ALAMEDA COUNTY
HEALTH CARE SERVICES

Subject: Fuel Leak Case No. RO0000265 and Geotracker Global ID T0600101680, Tony's Express Auto Services, 3609 International Blvd., Oakland, CA 94601 – Dissolved Oxygen Measurements

Subject: Fuel Leak Case No. RO0000265 and Geotracker Global ID T0600101680, Tony's Express Auto Services, 3609 International Blvd., Oakland, CA 94601 – Work Plan Approval

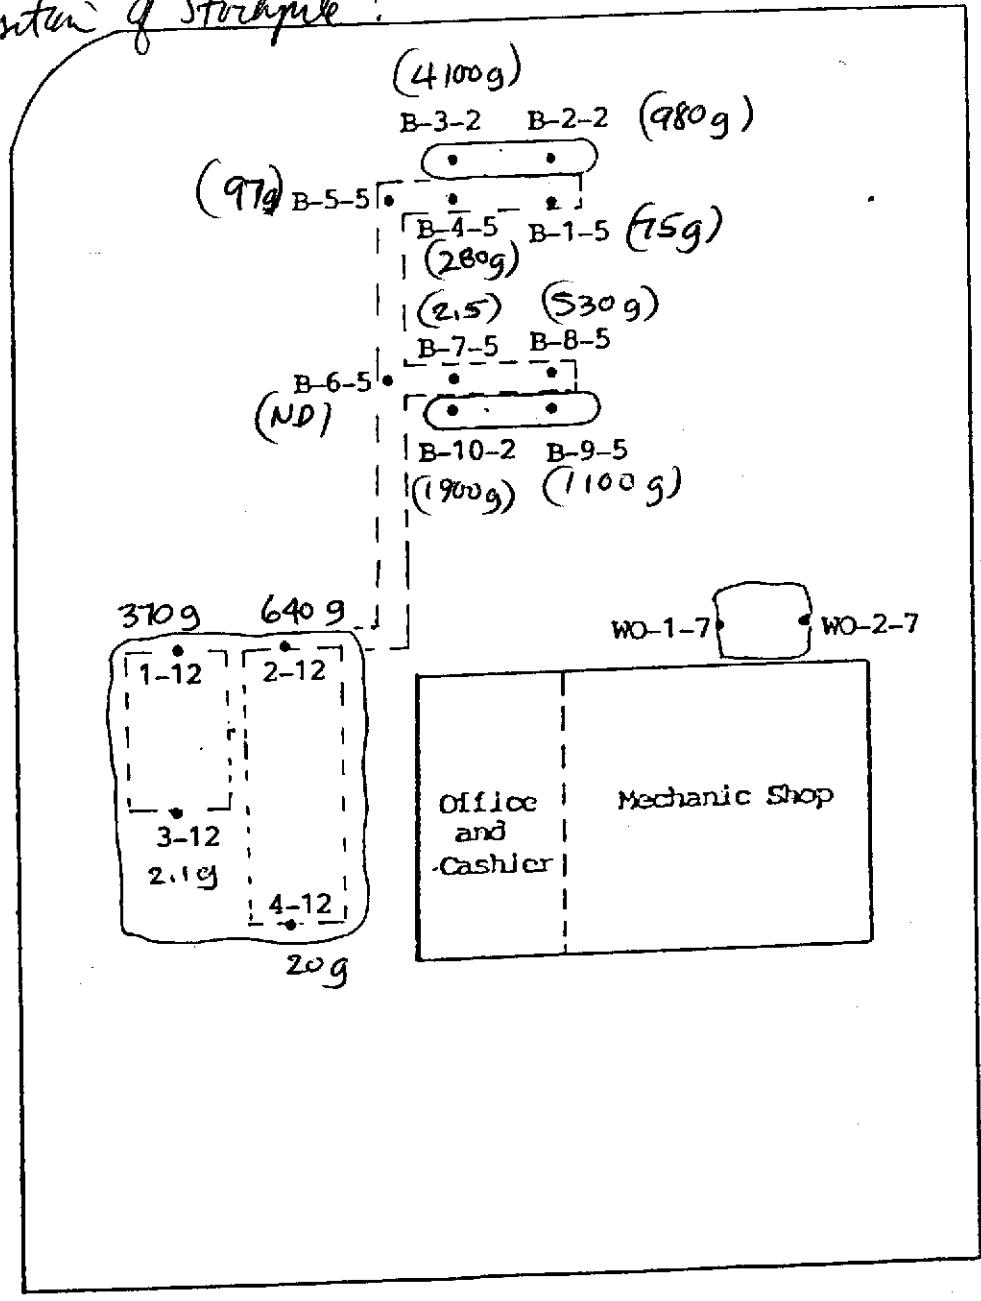
- ① Any overexcavation to set tank? , Any sample?
- ② need to run 8270 on a w/o sple per approved plan + T.R.G.
- ③ the ~~stockpile~~ stockpile from w/o EAST 14TH STREET needs to be run for w/o parameters for any reuse.
